SUBJECT: INCREASE IN THE SPENT FUEL POOL CAPACITY THROUGH THE USE OF HIGH DENSITY STORAGE RACKS, BYRON STATION, UNITS 1 AND 2 (TAC NOS. 62112 AND 63266)

Amendment No. 25
License No. NPF-37

SAFETY EVALUATION BY THE OFFICE OF NUCLEAR REACTOR REGULATION
RELATED TO THE INCREASE IN THE SPENT FUEL POOL CAPACITY
THROUGH THE USE OF HIGH DENSITY STORAGE RACKS

BYRON STATION, UNITS 1 AND 2

FIGURE 5.6-1
 MINIMUM BURNUP VERSUS INITIAL ENRICHMENT
 FOR REGION 2 STORAGE

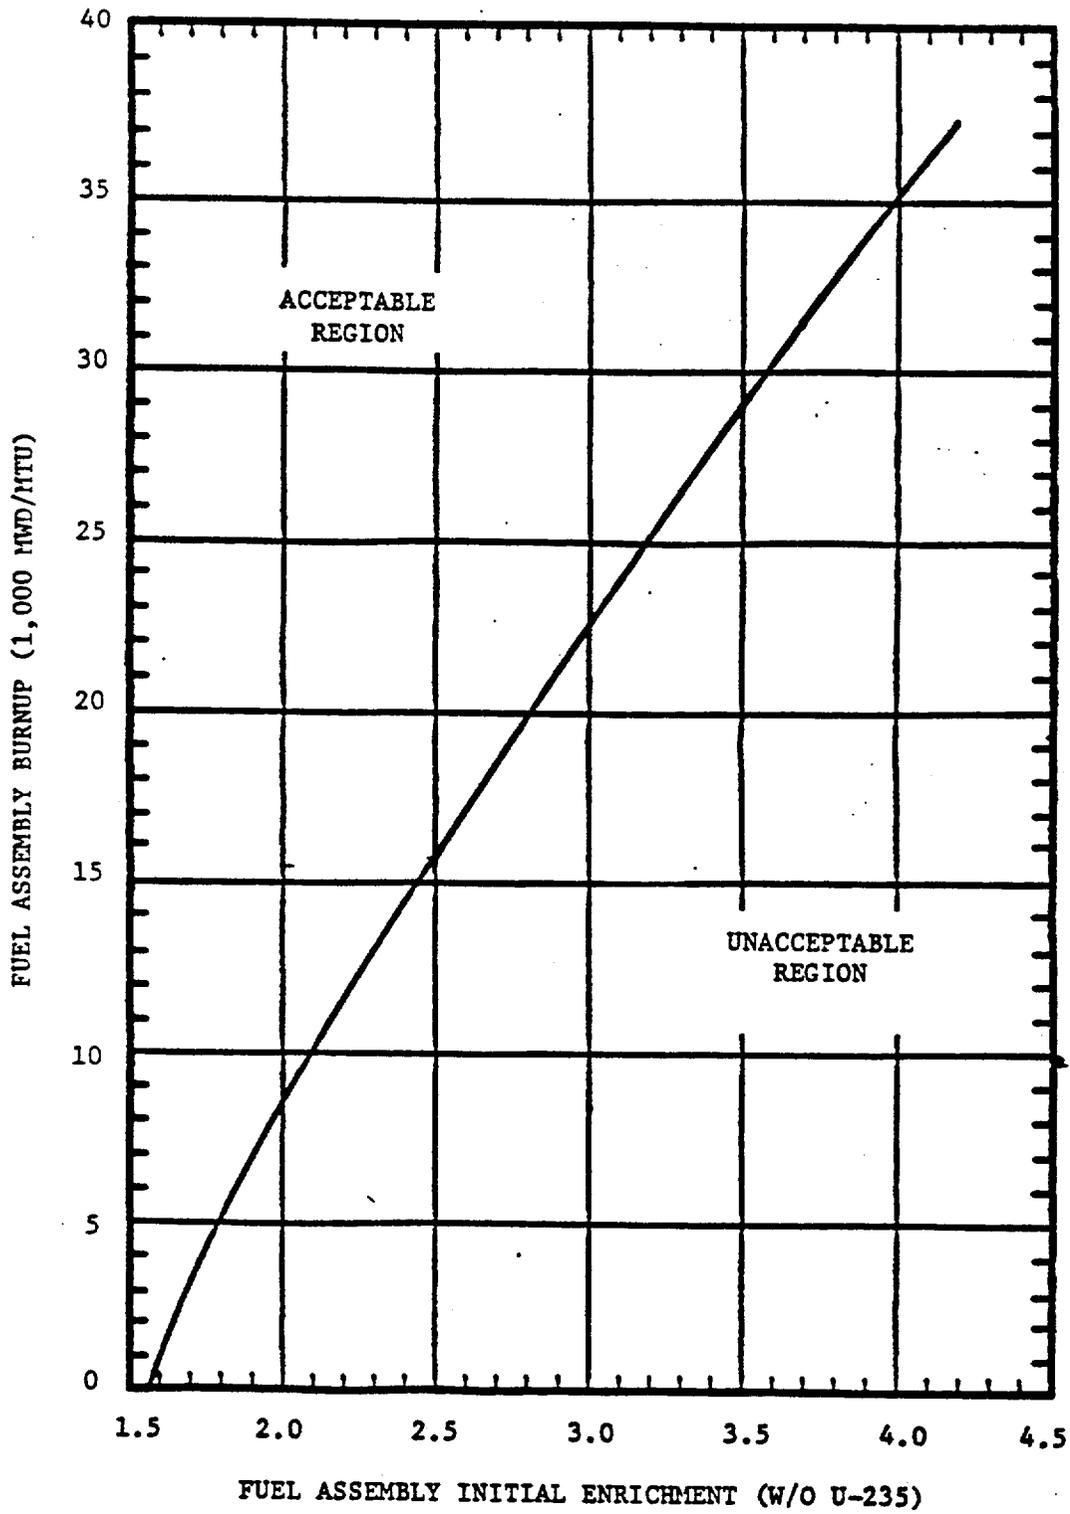
up to 4.2 weight percent U-235. Region 1 is also designed to store fuel assemblies with enrichments up to 4.2 weight percent U-235 that have not achieved adequate burnup for Region 2. The Region 2 cells are capable of accommodating fuel assemblies with various initial enrichments which have accumulated minimum burnups within an acceptable bound as depicted in proposed Technical Specification Figure 5.6-1.

Proposed Specification 5.6.1.1a refers to the FSAR for a description of the analysis methods and uncertainties. The FSAR will be updated to be consistent with the methods and uncertainties of the present analyses. This is acceptable. This Specification also references Figure 5.6-1, which will be added to the Specifications, for the curve of minimum burnup as a function of initial enrichment required for storage in Region 2. This curve is consistent with the analyses and is acceptable.
